# PERMIT

SEWAGE DISPOSAL SYSTEM

# APPLICATION

PERCOLATION TESTING

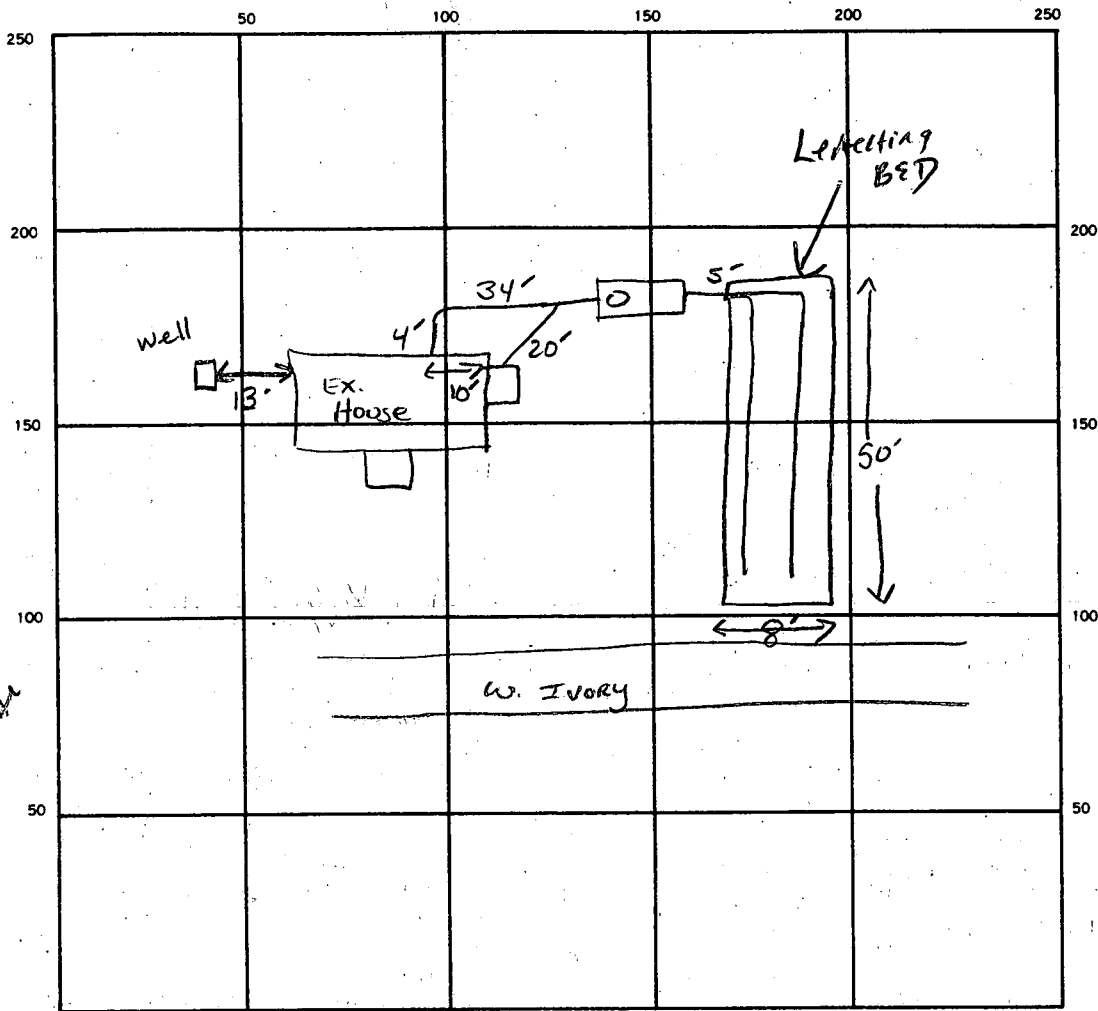
This repair was done before we perced Indians Gun Subdivision. I suspect it is in the water table or very close to it. The next repair should be on a holding tank.

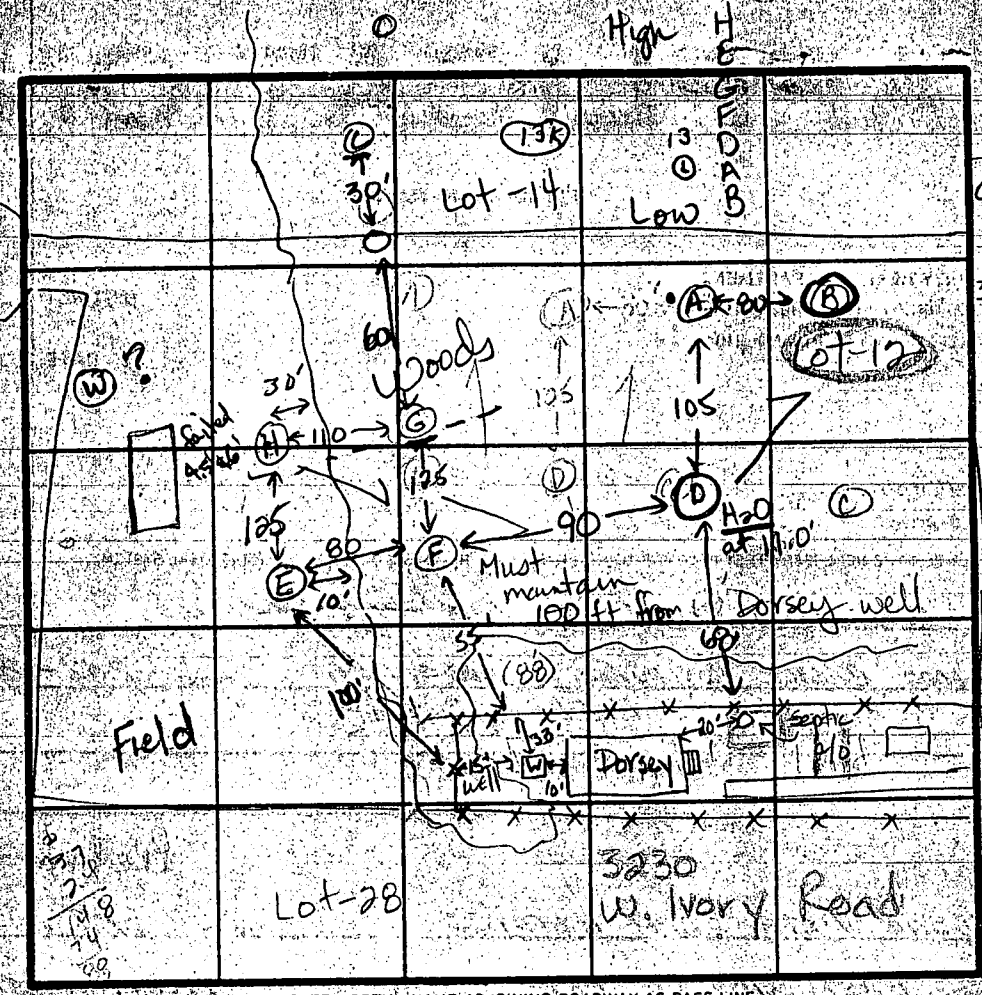
REASONS FOR REJECTION OR HOLDING 8-24-88 Pending perc hole locations. Hole (F) must be  
moved away from existing well (at least 100'). For subdivision plat  
approval. JEN.

REMARKS: \* (E) Too close to Dorsey Property's well  
Holes moved up to higher ground. Lot 16 septic may impact on Lot 12 well. Review carefully  
TYPE OF SOIL: 0-5 br silt, 20% broken rock 5-14 Rd-br silt  
TESTED BY: Jane E. Nadeau ALSO PRESENT: Phillip, Roger
